# Access Compliance Report

## Public Rights-of-Way

Intersection ID: 11174	Main Street: HARRISBURG_RD	Cross Street: TIMBERTOP_LN	Location: S
ADA ID: B4A191385C4A	Ramp Type: Perp	Initial Pass/Fail: Fail	Overall Compliance: No
Severity Score: 28.75			
Codes/Mitigation Info/Possible Solution		Field Measurements/Component Compliance

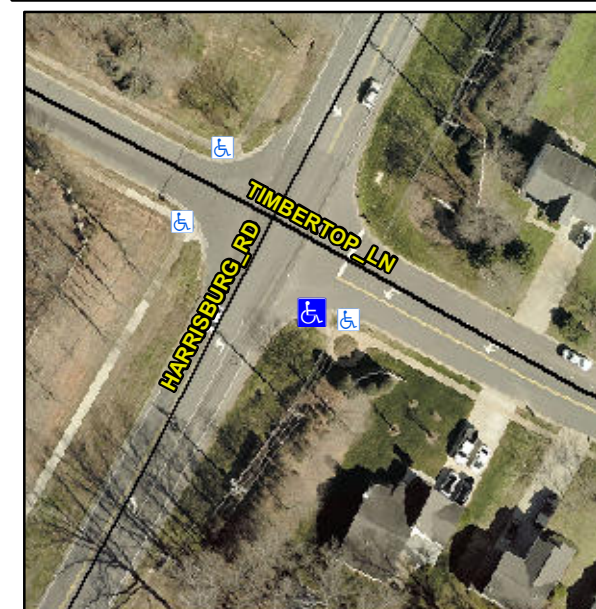
**Remove & Replace Entire Ramp.**

**Not Found, R304.2.2, R304.5.3, R302.7**

Compliance	Description	Data	Compliance	Description	Data
N/A	Ramp Length (in)	74.0	No	Ramp Slope (%)	10.0
Yes	Ramp Width (in)	68.0	No	Ramp XSlope (%)	2.7
N/A	Flare Type LT	N/A	N/A	Flare Type RT	N/A
N/A	Flare Slope LT (%)	N/A	N/A	Flare Slope RT (%)	N/A
N/A	Flare Traversable LT?	N/A	N/A	Flare Traversable RT?	N/A
N/A	Landing Length (in)	N/A	N/A	DWS Provided?	N/A
N/A	Landing Width (in)	N/A	N/A	DWS Contrast?	N/A
N/A	Landing Slope (%)	N/A	N/A	DWS Length (in)	N/A
N/A	Landing X Slope (%)	N/A	N/A	DWS Full Width?	N/A
N/A	Landing Curb? (Y/N)	N/A	N/A	DWS Offset (in)	N/A
N/A	Shared Landing?	N/A			
N/A	Gutter Ponding?	N/A	N/A	Gutter Slope (%)	N/A
N/A	Gutter Lip Ht (in)	N/A	N/A	Gutter X Slope (%)	N/A
N/A	Painted X Walk1?	No	N/A	Painted X Walk2?	N/A
	X Walk 1 Direction	To NW		X Walk 2 Direction	N/A
N/A	X Walk 1 Width (in)	N/A	N/A	X Walk 2 Width (in)	N/A
	X Walk 1 Slope (%)	7.7		X Walk 2 Slope (%)	N/A
	X Walk 1 X Slope (%)	1.2		X Walk 2 X Slope (%)	N/A

N/A	Ramp inside XWalk1?	N/A	N/A	Ramp inside XWalk2?	N/A
	Road Slope (%)	N/A	N/A	Clear Space?	N/A
	Road X Slope (%)	N/A	N/A	Clear Space to XWalk (in)	N/A
N/A	Any Obstructions?	N/A	N/A	Storm Grate/Utility Hazard?	N/A
	Obstruction Type			Storm Grate/Utility Type	
		N/A			N/A
		No		Surface Condition? (G/P)	Poor
